MODEL
2017MY
Sportage (QL)

NUMBER
153

TECHNICAL SERVICE BULLETIN

SUBJECT: SERVICE ACTION: FRONT POWER SEAT BACK BOARD STRAP REPOSITIONING (SA249)

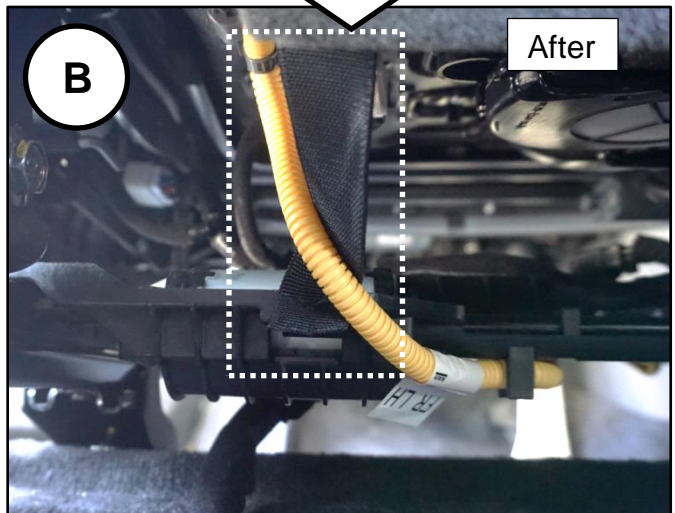
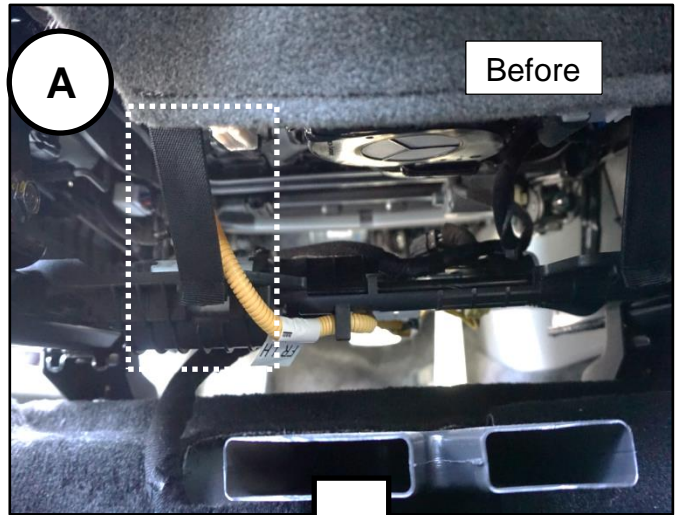
This bulletin provides information related to the repositioning of the front power seat back board strap for 2017MY Sportage (QL) vehicles produced from December 10, 2015 through October 10, 2016 due to interference between the side air bag harness and front seat back board strap. This interference may cause a noise when moving the front seat forward/backward and up/down. Kia is requesting the completion of this Service Action on all affected vehicles in dealer stock prior to delivery. Before conducting the procedure, verify the vehicle is included in the list of affected VINs.

3. Reposition the front seat back board strap (A) between the side air bag harness and the seat rail (B). Make sure the harness is positioned outboard of the strap. See pictures.

1. Move seat full forward.
2. Check the position of the side air bag harness and front seat back board strap below the front seat.

If the vehicle is equipped with a power seat on the passenger side, repeat steps 1-3.
